WESTERN SYDNEY UNIVERSITY BANKSTOWN CITY CAMPUS

AMENDED DEVELOPMENT APPLICATION AND RESPONSE TO SUBMISSIONS REPORT

Prepared for
WESTERN SYDNEY UNIVERSITY
26 August 2020

Figure 1 - Building form revisions diagram

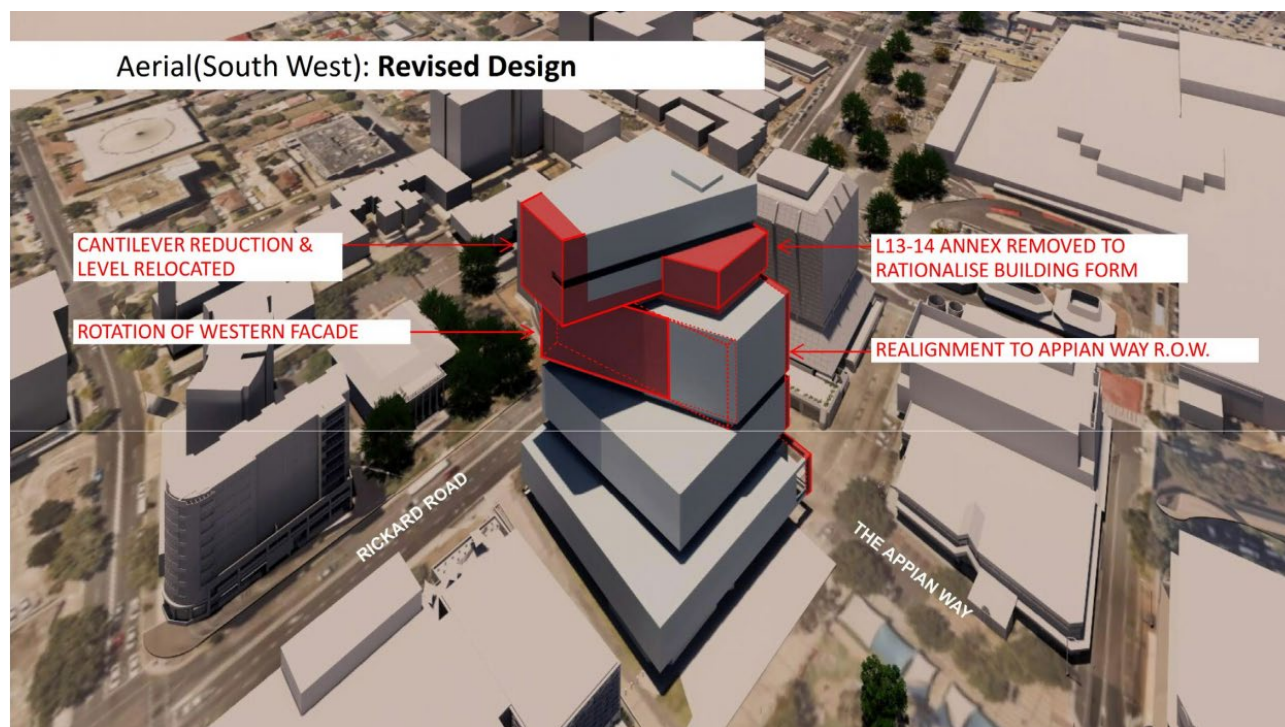
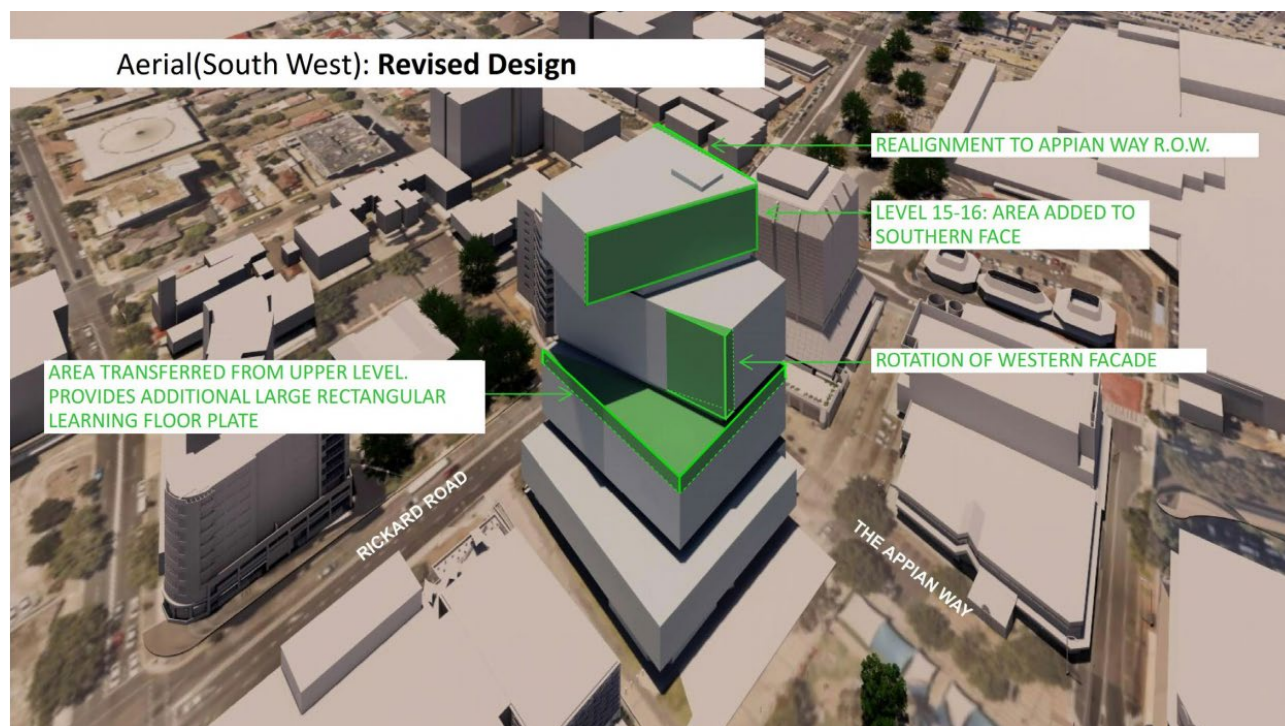
Key building form changes in the revised design include:

- Altering the alignment of the east façade to match the new Right of Way boundary that delineates The Appian Way creating a clear alignment and visual connection to Bankstown Train Station to the south.
- Reducing the cantilevered volume, in both height and length resulting in reduced perception of bulk when viewed from Paul Keating Park.
- Simplifying of the overall building form to improve the legibility of the building (removal of the Level 13/14 annex and terrace).
- Review of the façade treatments, including how they delineate and articulate the form.
- Reducing the extent of south facades facing Paul Keating Park further reducing the perception of bulk from this vantage point.
- Redistributing the balcony and terrace locations within the overall form to ensure a visual connection with Paul Keating Park.

The adjustments to the building form illustrated in **Figure 1** and described in further detail in **Section 4.6** have resulted in a building that responds to its urban context.

Figure 3 - Revised Massing

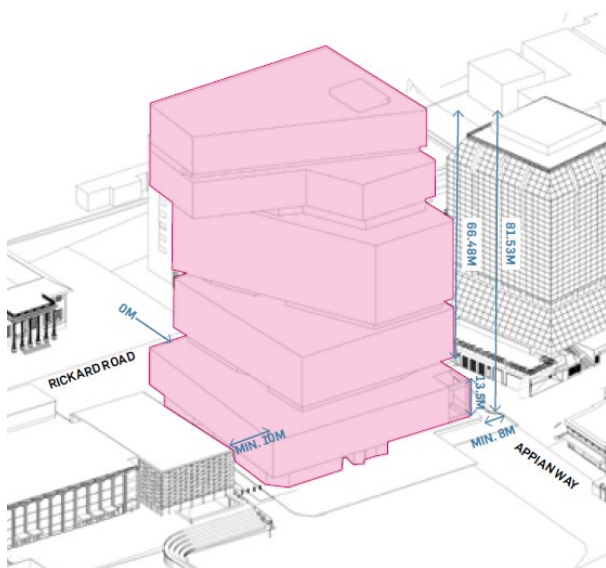
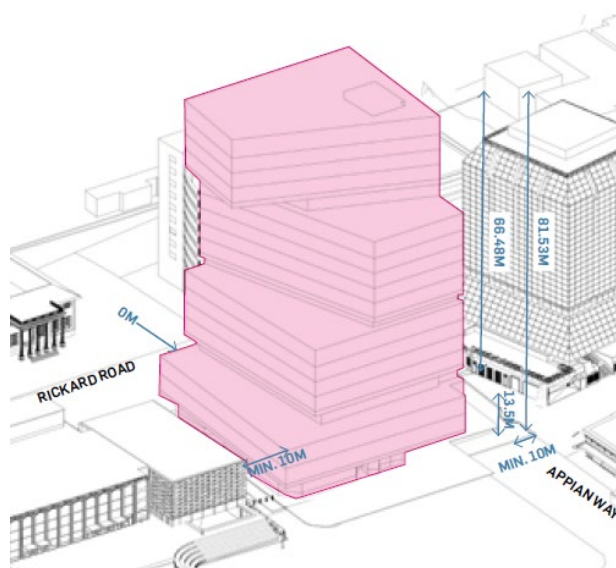
Reducing the cantilever volume (**Figure 3**), increases solar access to Paul Keating Park at mid-winter.

Figure 4 - Comparison of compliance with solar access control

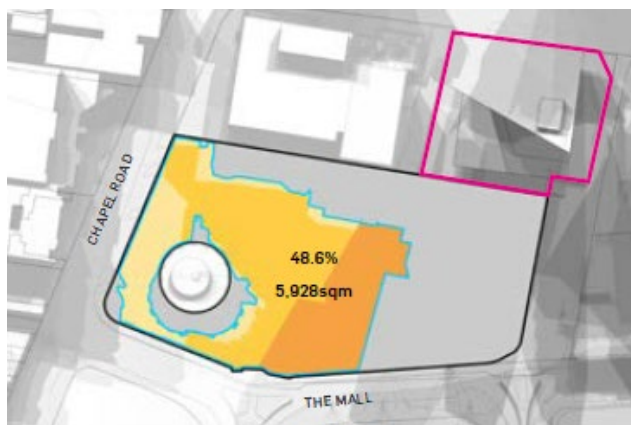
In summary the EIS design resulted in 48.6% of Paul Keating Park achieving at least 4 hours of continuous solar access at mid-winter between 10am and 3pm, whilst the revised design results in 50.7% as illustrated in **Figure 4** and complies with Council's proposed solar access control.

Figure 16 - Proposed Basement

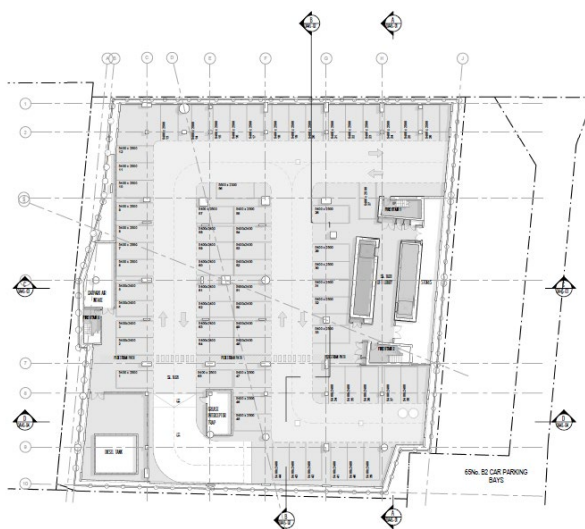
In response to the new easements on the title, the two basement levels have been redesigned with a reduced floor plate as illustrated in **Figure 15** above.

Services plant, carparking circulation, waste collection loading and bicycle parking have been relocated within the site. The basement vehicle entrance ramp from the BLaKC driveway has been retained, with separate pedestrian and cyclist access located alongside.

Figure 22 - Stormwater infrastructure

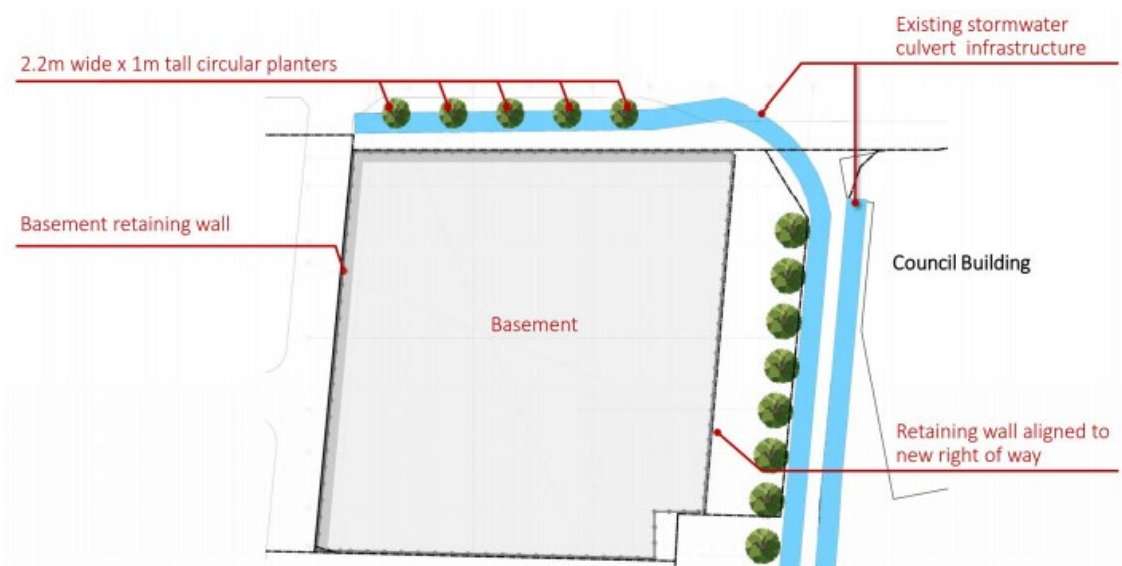
The revised design incorporates the following changes in comparison to the EIS design:

- New street tree locations in response to in-ground services infrastructure;
- Realignment of the pop-up space façade to align with the main façade;
- Reduced extent of the void above the main entrance;
- Reduced number of columns along the undercover walkways;
- Revised materials to the ground level façade and soffit;
- Additional bike parking;
- Coordination with landscape, traffic and civil design outcomes.

Street trees in above ground planters are proposed along Rickard Road due to the presence of substantial below ground stormwater infrastructure (**Figure 22**). Trees include 5 'Sydney Golden Wattle' (*Acacia longifolia*) which are native to south eastern Australia. Under ideal growing conditions this species reaches a mature height and spread of 6m x 6m. The trees will be planted in GRC pots 1m deep by 2.2m in diameter. The soil volume for these trees will be approximately 4m³.

Figure 28 - Revised design with Original SSDA Design outlined.

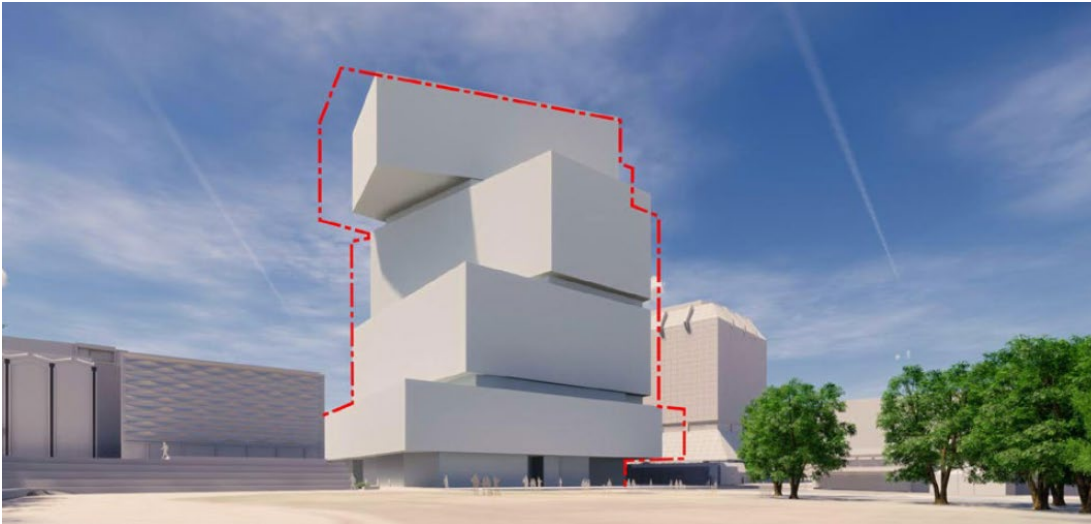
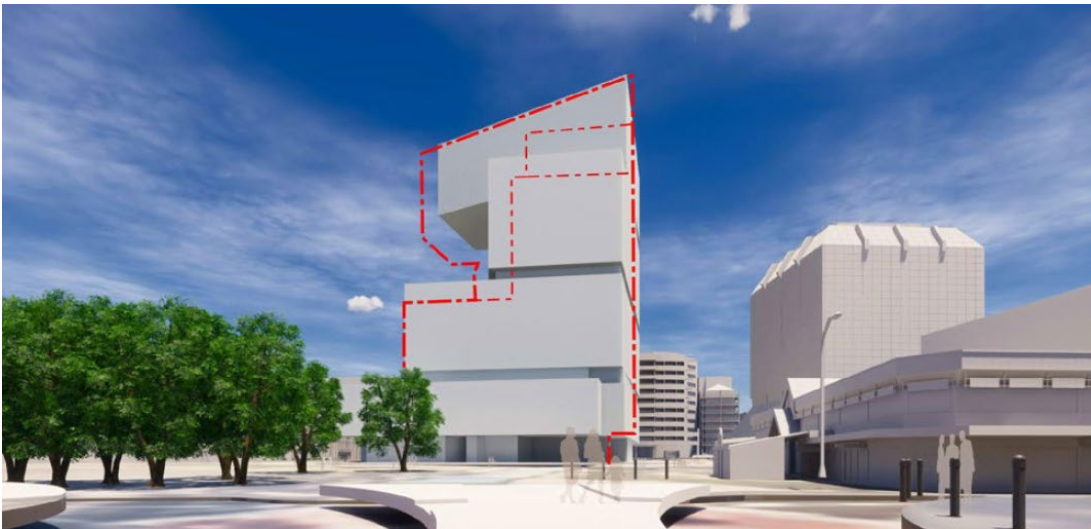
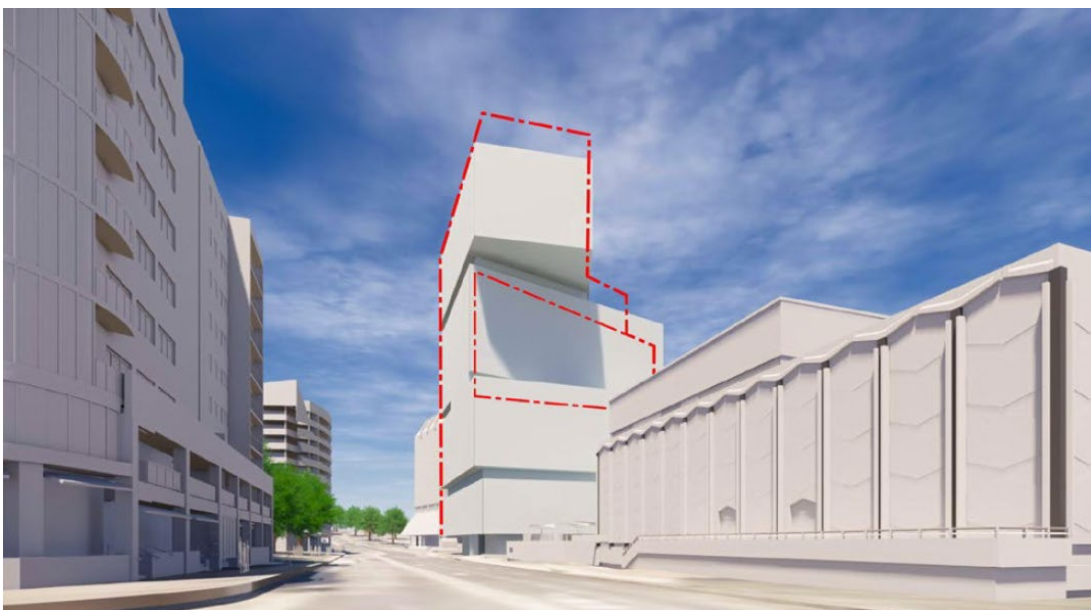
The upper tower includes a smaller floor plate with south facing outdoor terrace at Level 14, and the reduced cantilevered form comprising Levels 15 to 18. This component of the building includes two recessed balconies (one facing north, one south).

Figure 35 - Revised Terrace locations

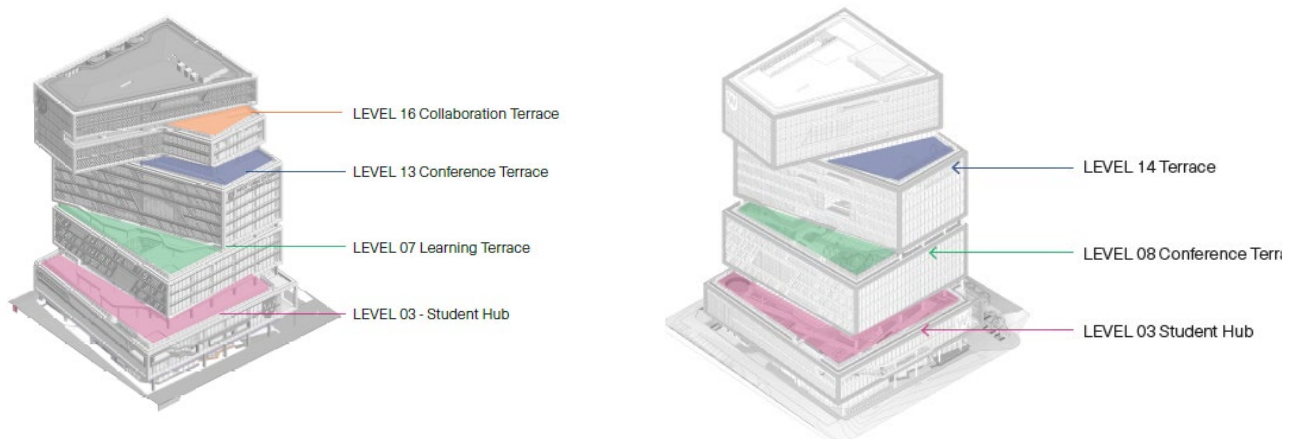
The revised design has removed the southern annex from the cantilever volume which created the level 16 terrace, and increased the size of the level 14 (previously level 13) terrace (see **Figure 35**).
